ADDENDUM NO. 1 TO BID FORMS

**CORONA-NORCO UNIFIED SCHOOL DISTRICT
PURCHASING DEPARTMENT
Bid No. 2023/24-204**

CORONA FUNDAMENTAL INTERMEDIATE SCHOOL MPR MODERNIZATION

SHEET NO.:
A-111

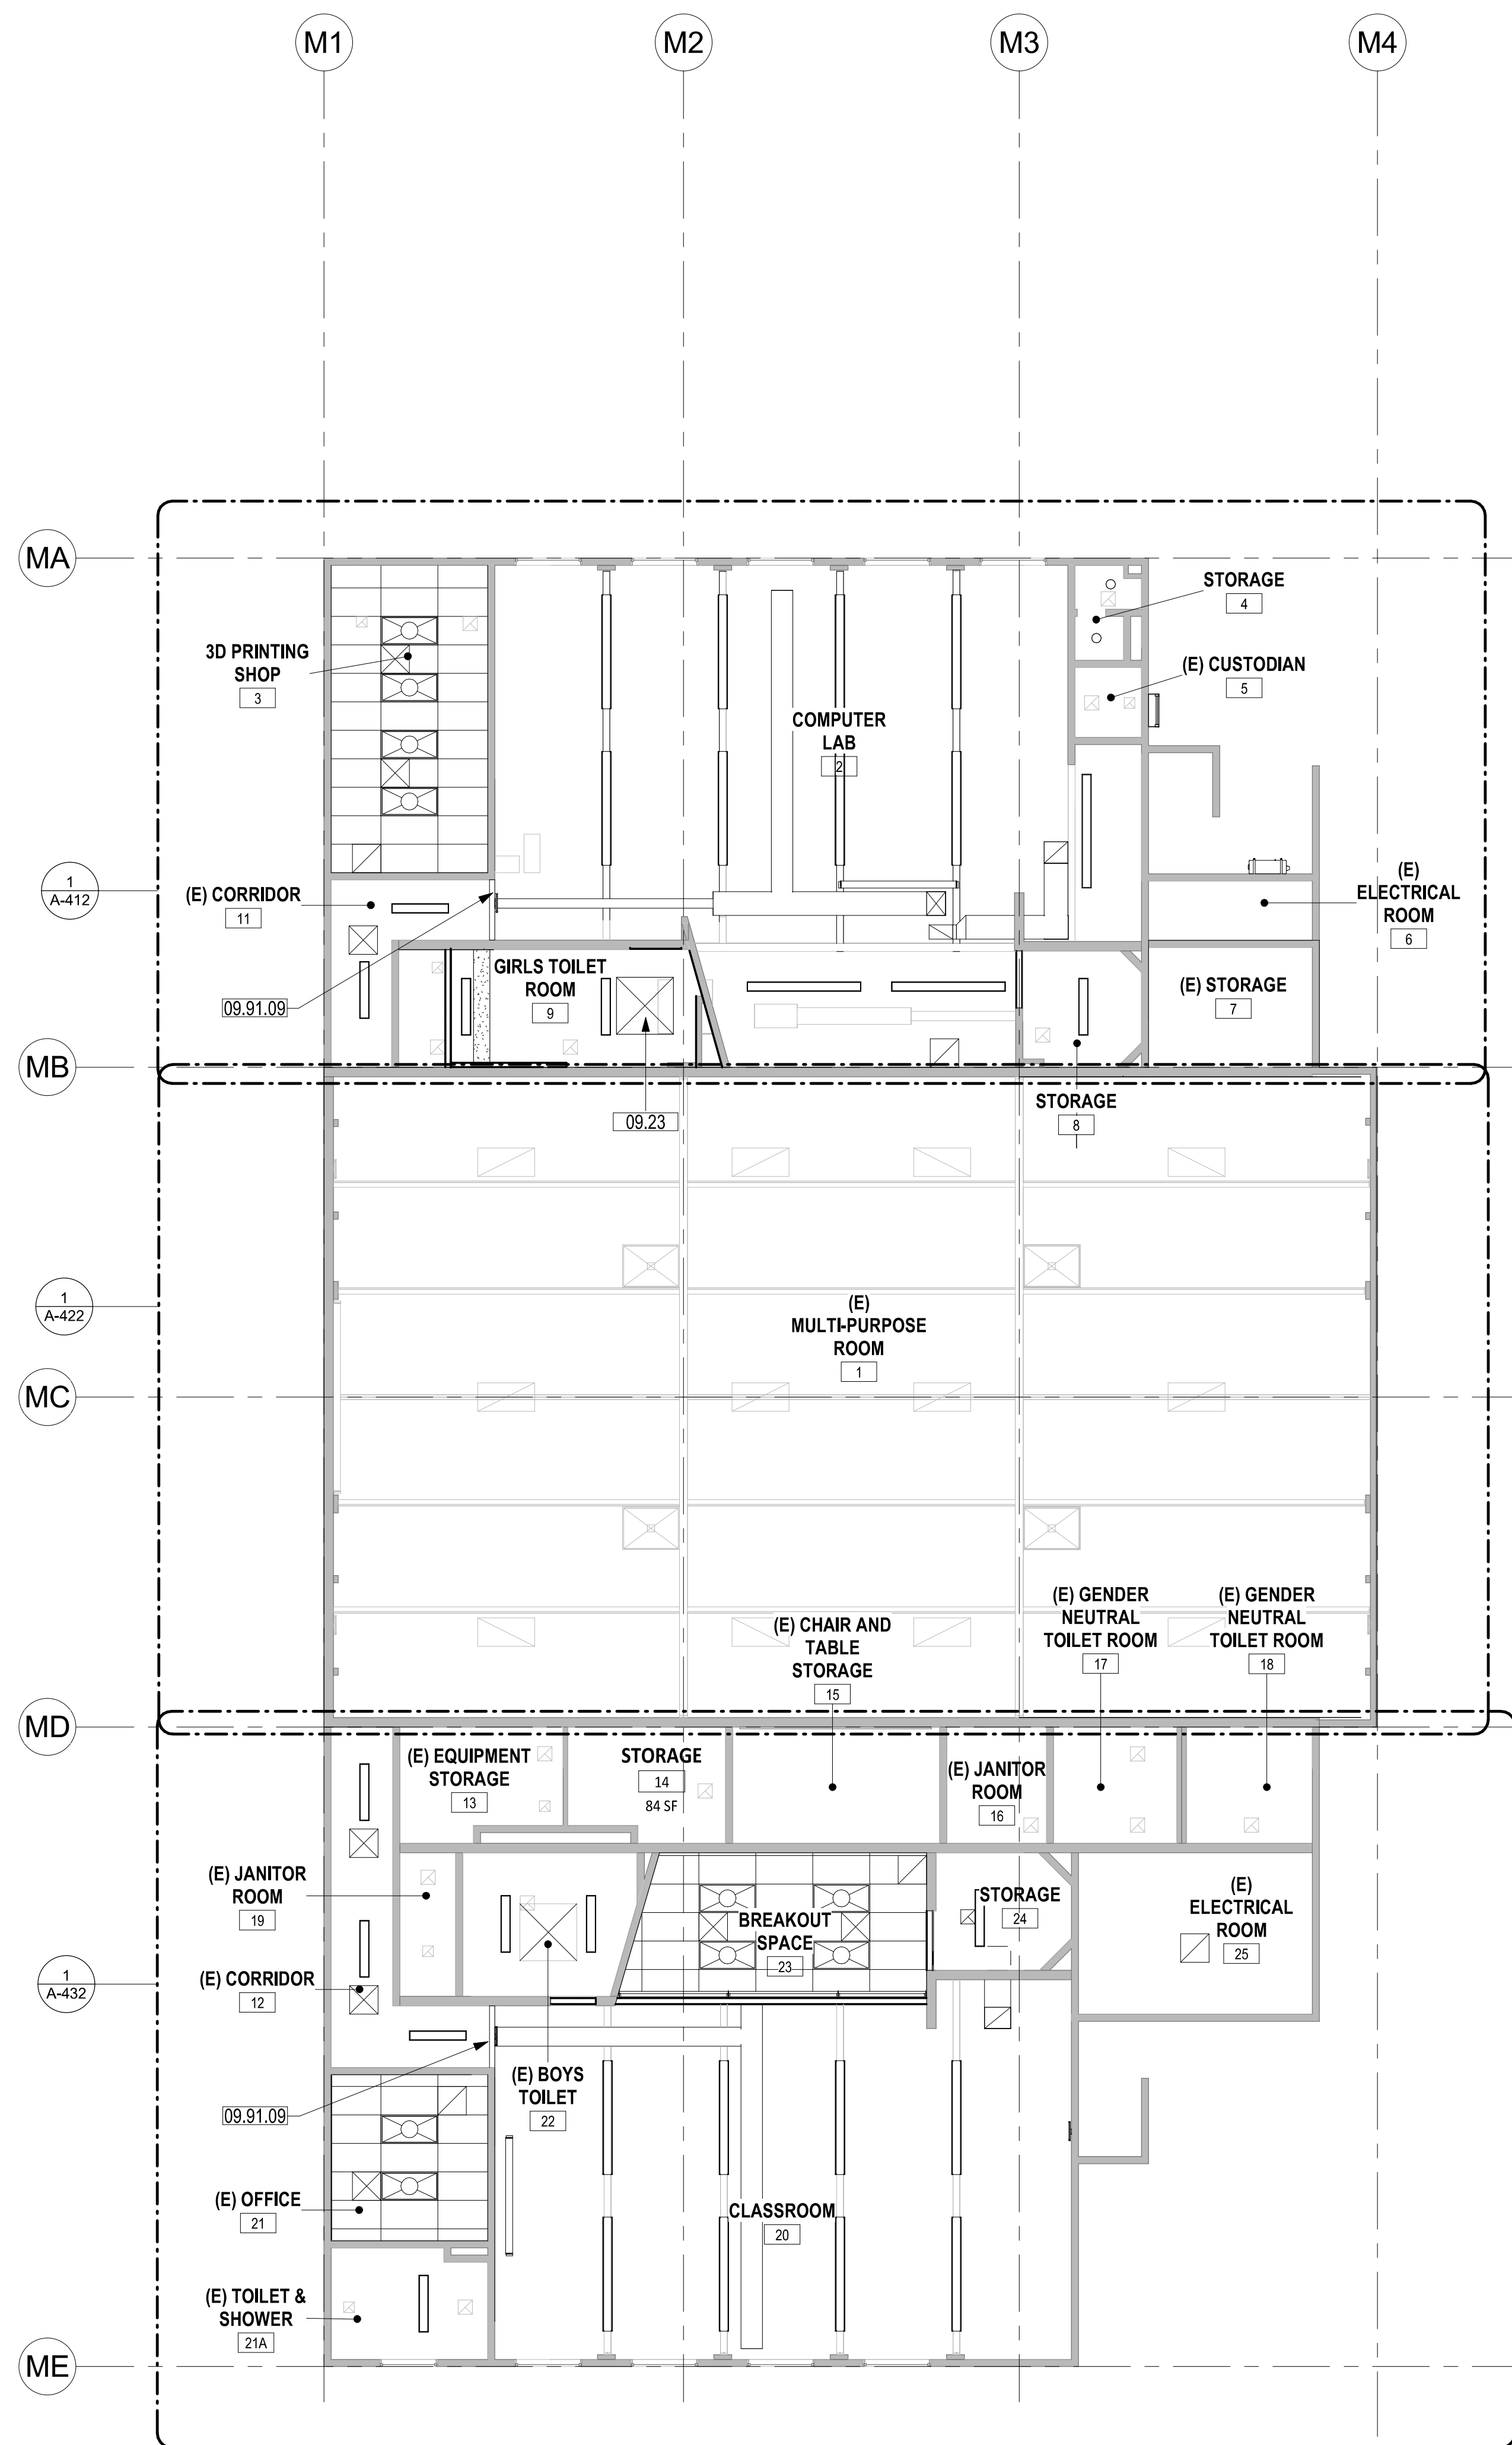
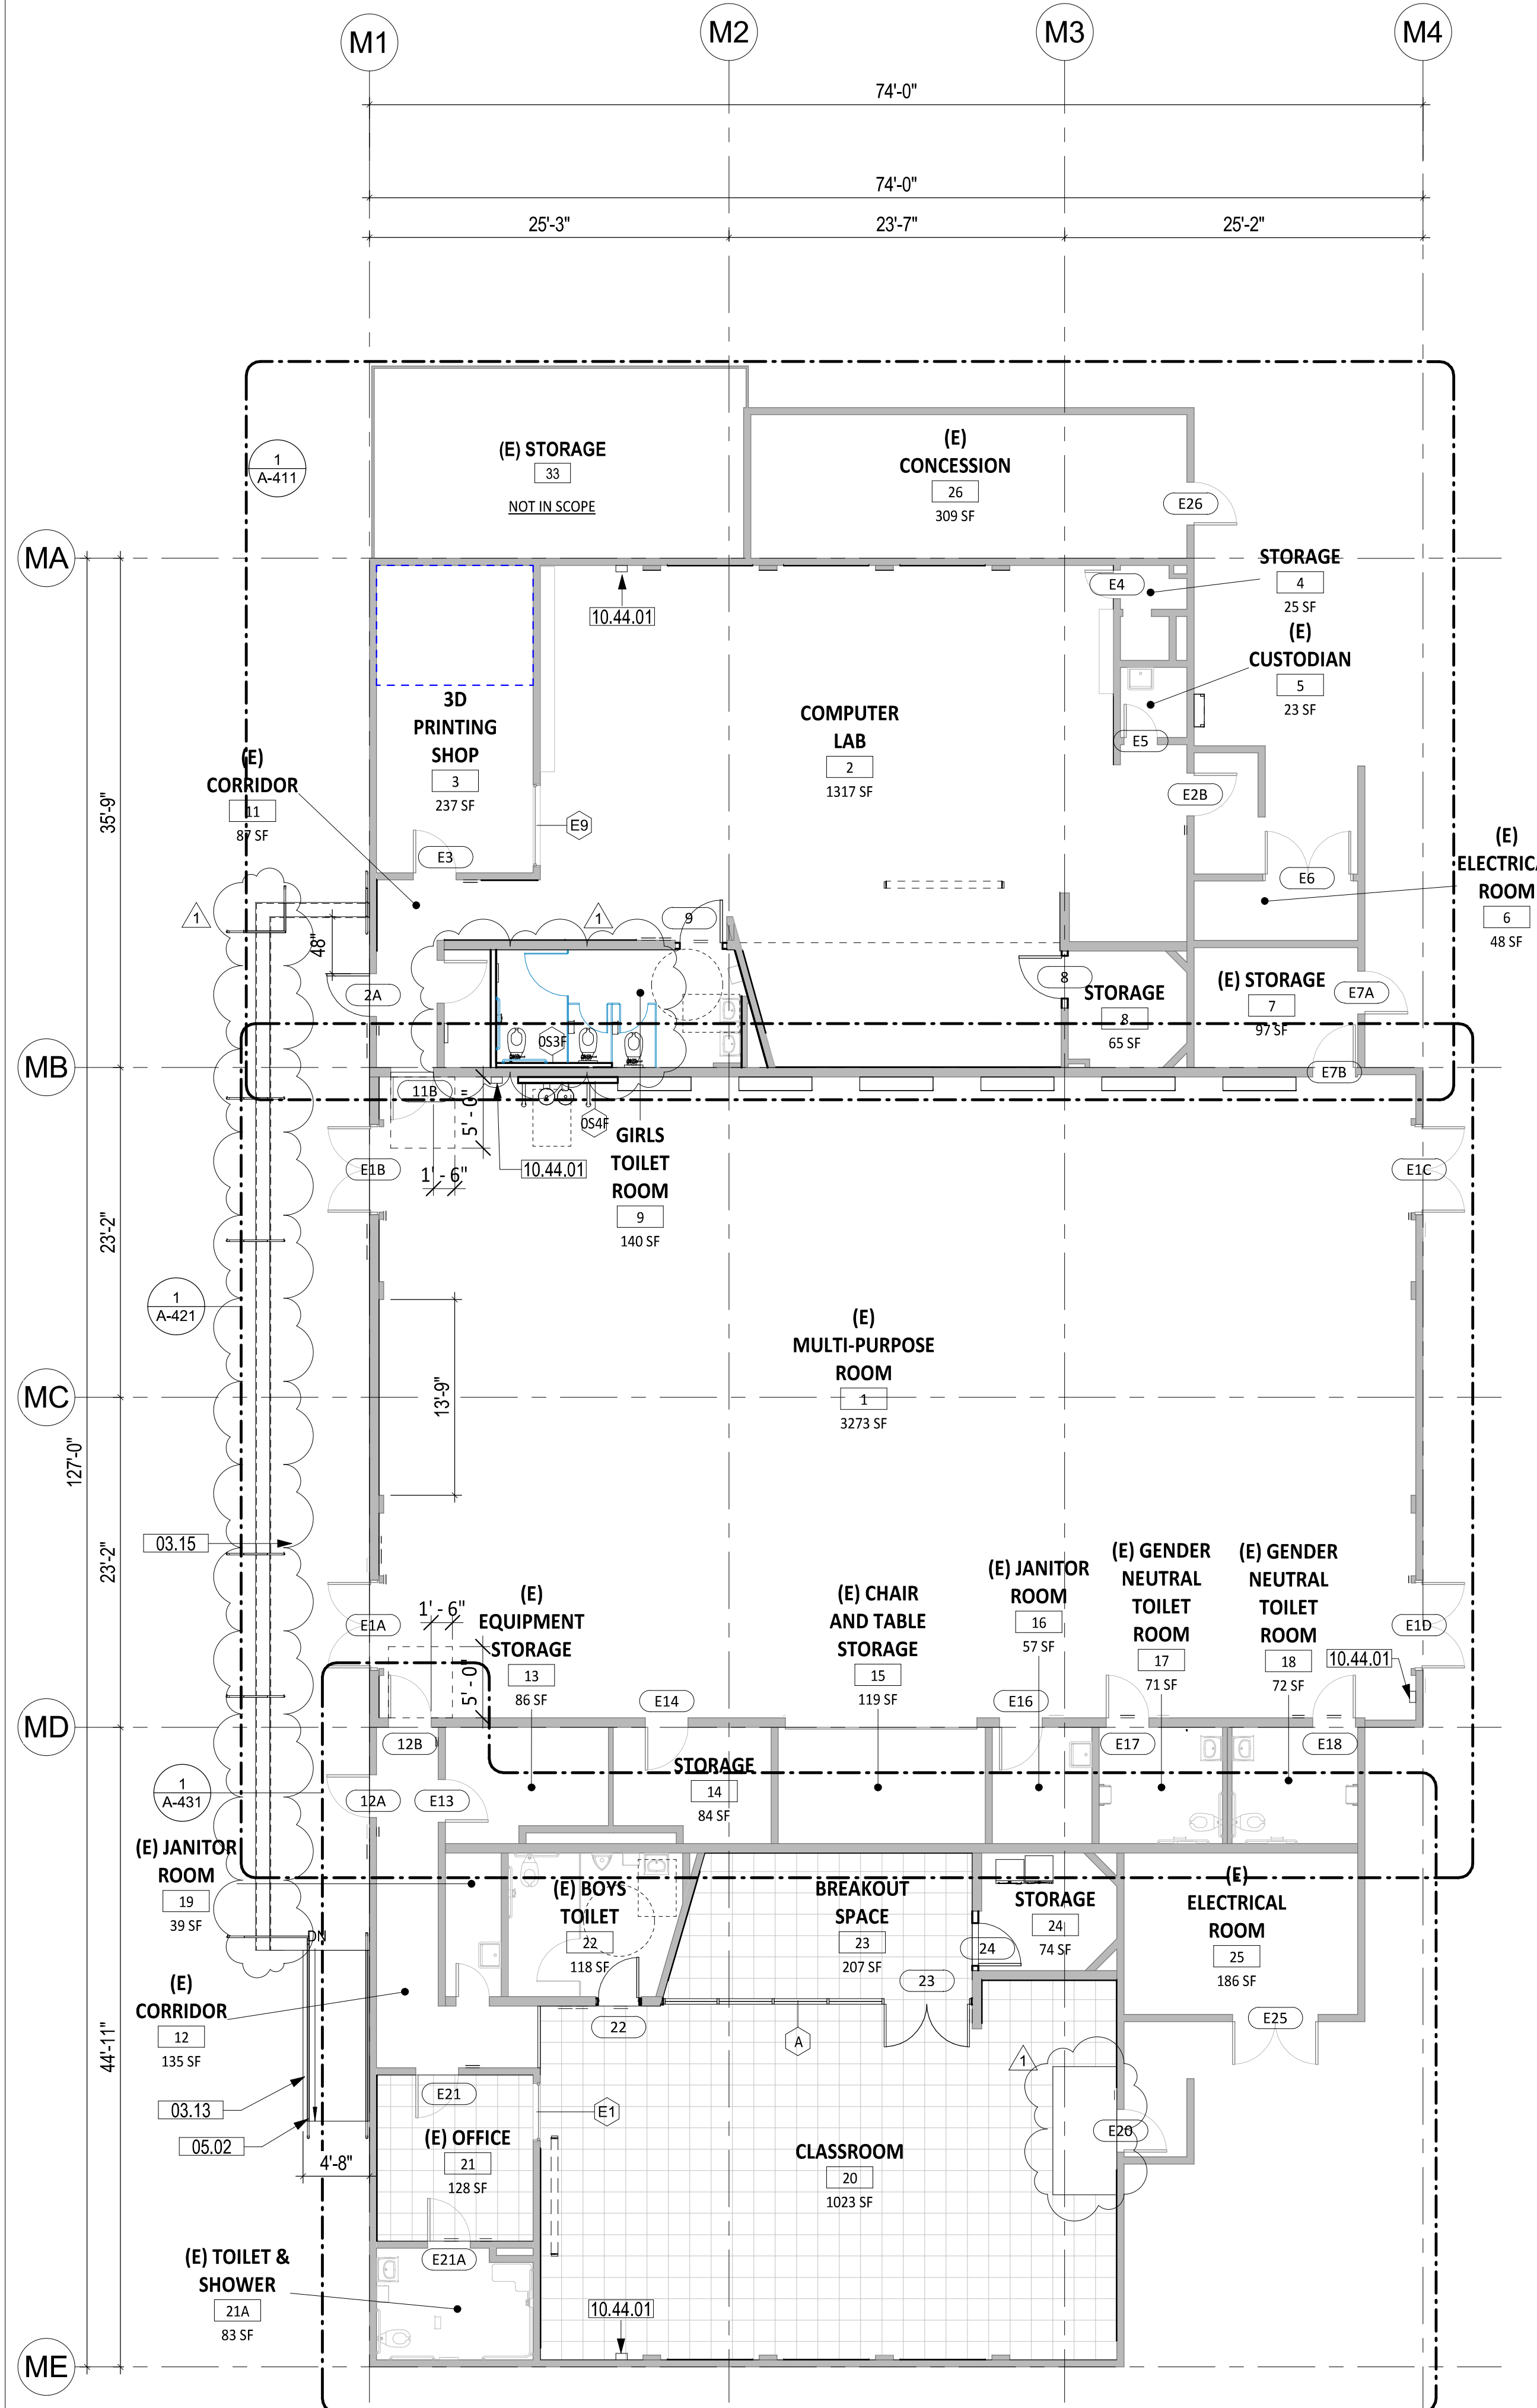
Item No. 1.04
Sheet A-111 - 1ST FLOOR PLAN & RCP - OVERALL

- Added Sheet Note 5 for work on ceilings and walls
- Added Sheet Note 6, Extron System
- West concrete landing layout revised
- Girls' Toilet Room 9 layout revised
- Floor mat added at Door E20 in Classroom 20
